MEMORANDUM

To: The Design Advisory Board
From: Mary O'Neil, AICP, Principal Planner
RE: ZP21-457, 43 Adams Court
Date: July 13, 20221

File: ZP21-457 OG
Location: 43 Adams Court
Zone: RL **Ward:** 6S
Parking District: Neighborhood Parking District
Date application accepted: May 25, 2021
Applicant/ Owner: Jake Pill
Request: Rebuild north facing dormer and add south facing dormer with 7' ceiling height, rebuild back deck and stairs to code, request for a one space parking waiver for the total number of spaces to 3; remove false chimney.

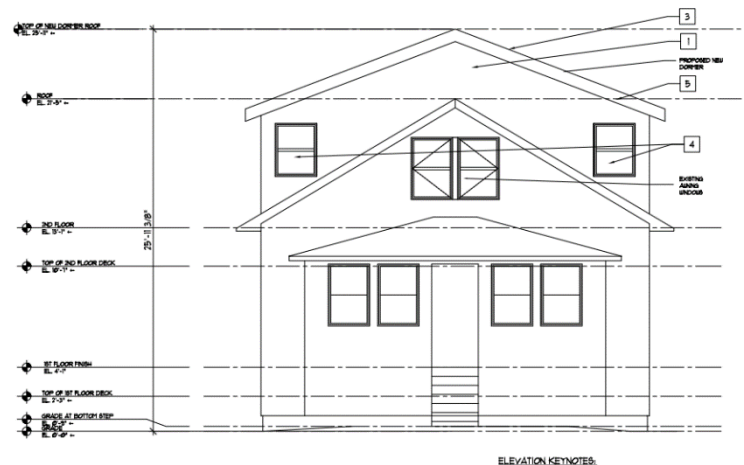
43 Adams Court is among a group of modest Craftsman style bungalows constructed in the 1920s on Adams Court. Two of them have already seen oversized rear additions, completed under different regulations and likely before the street was listed on the Vermont State Register in 2005. The tendency to pop the roof and create either an oversized addition or roof wings on these characteristically small residences negatively affect the historic integrity of the structure; oftentimes at the expense of its inherent design. The proposed dormers are out of scale with the plan' their height and additional roof mass disruptive to the very distinct architecture.

The over-roof dormers appear as gable front from the street, but are in fact a “saddle” atop the existing structure.

The 2nd story replacement windows are clearly unsympathetic with the existing Craftsman style home. The proposed dormers contradict Preservation Brief #14 relative to additions on historic structures, in that they fail to be compatible with the massing, size, scale, and architectural features to protect the historic integrity of the property and its environment. The saddle-type

placement, on top of the existing ridge and extending on both the north and south sides of the dwelling overpower the original structure and mar its integrity.
